DAWSON POINT SUBDIVISION

APPLICATION NUMBER 13 DATE September 15, 2005

REQUEST Subdivision

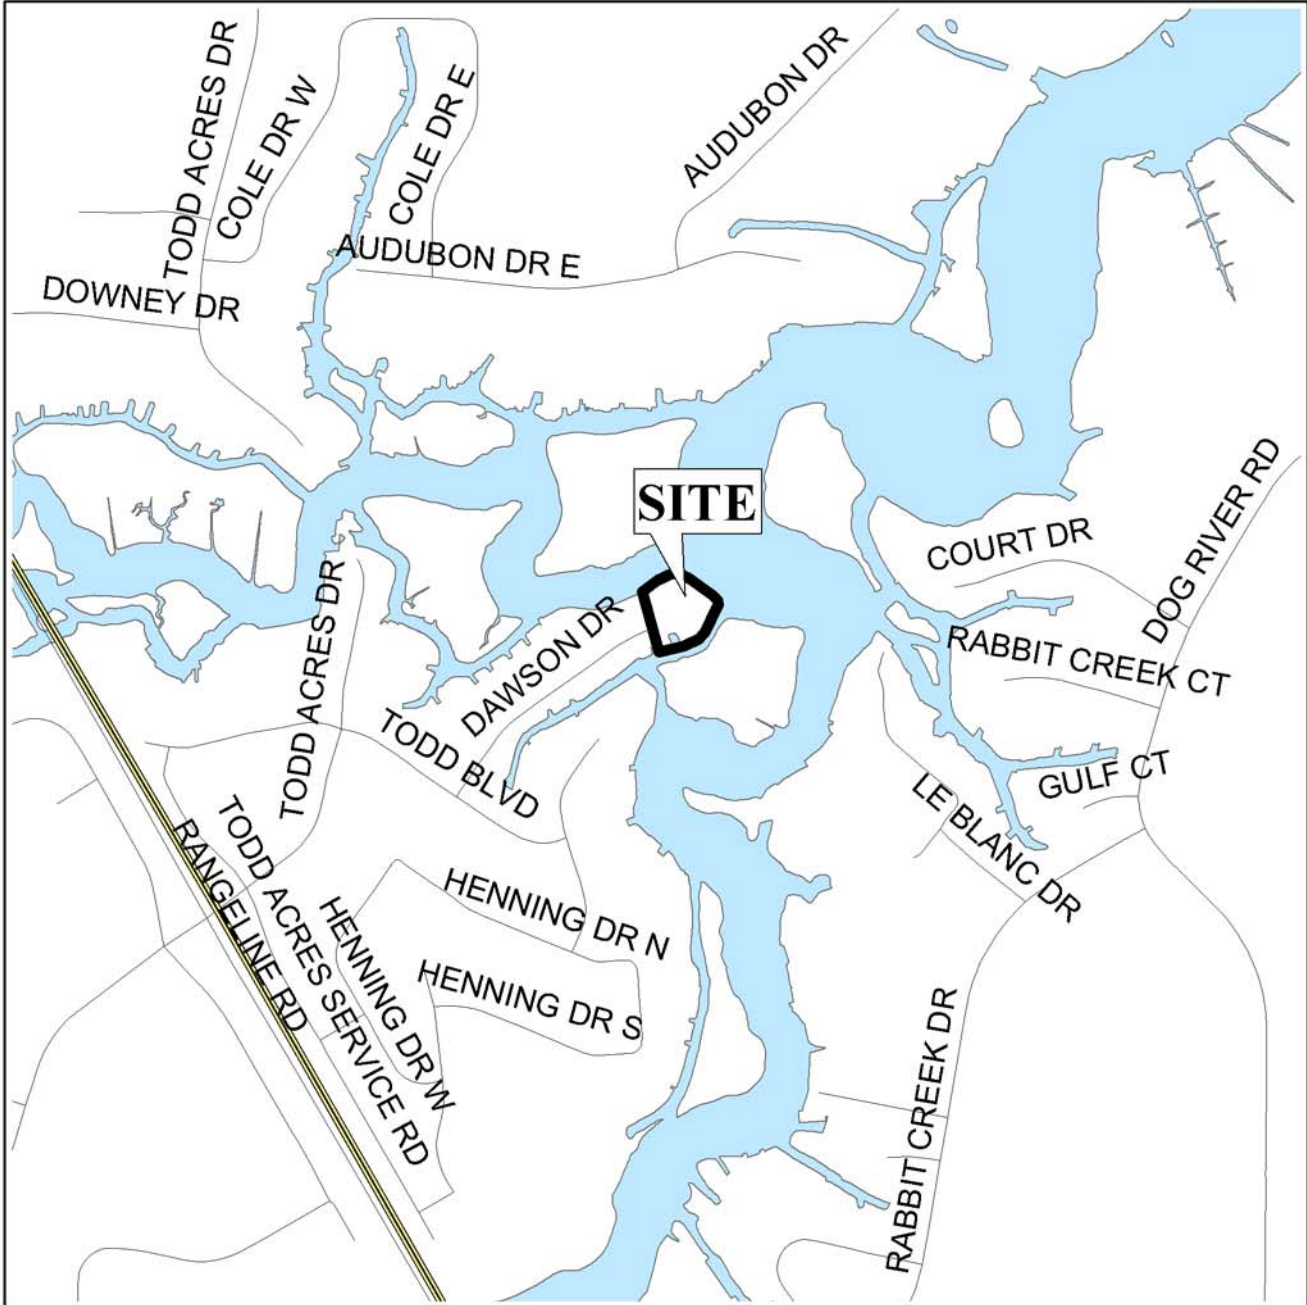
Engineering Comments: The minimum finished floor elevation required on each lot affected by the x-shaded and/or AE flood zone on the final plat. A drainage easement will be required if any portion of this property conveys stormwater runoff from a COM maintained rights- of way. Must comply with all stormwater and flood control ordinances. Any work performed in the right of way will require a right of way permit.

Traffic Engineering Comments: Driveway numbers, size, location and design to be approved by Traffic Engineering and conform to AASHTO standards.

The plat illustrates the proposed 5 lot, 1.36 ± acres subdivision which is located on the terminus of Dawson Drive and is in City Council District 4. The subdivision is served by public water and sanitary sewer.

The purpose of this application is to combine two lots and a metes and bounds parcel into five lots.

As the site is along Rattlesnake Bayou and Rabbit Creek, the area may be environmentally sensitive; therefore, the approval of all applicable federal, state and local agencies would be required prior to the issuance of any permits.

Additionally, any new cul de sac for the site is to be dedicated and constructed to meet COM Standards.

The plat meets the minimum requirements of the Subdivision Regulations and is recommended for Tentative Approval subject to the following conditions: 1) the approval of all applicable federal, state and local agencies prior to the issuance of any permits; 2) dedication and construction of new cul de sac to meet COM Standards; and 3) full compliance with Engineering comments (*The minimum finished floor elevation required on each lot affected by the x-shaded and/or AE flood zone on the final plat. A drainage easement will be required if any portion of this property conveys stormwater runoff from a COM maintained rights- of way. Must comply with all stormwater and flood control ordinances. Any work performed in the right of way will require a right of way permit*).
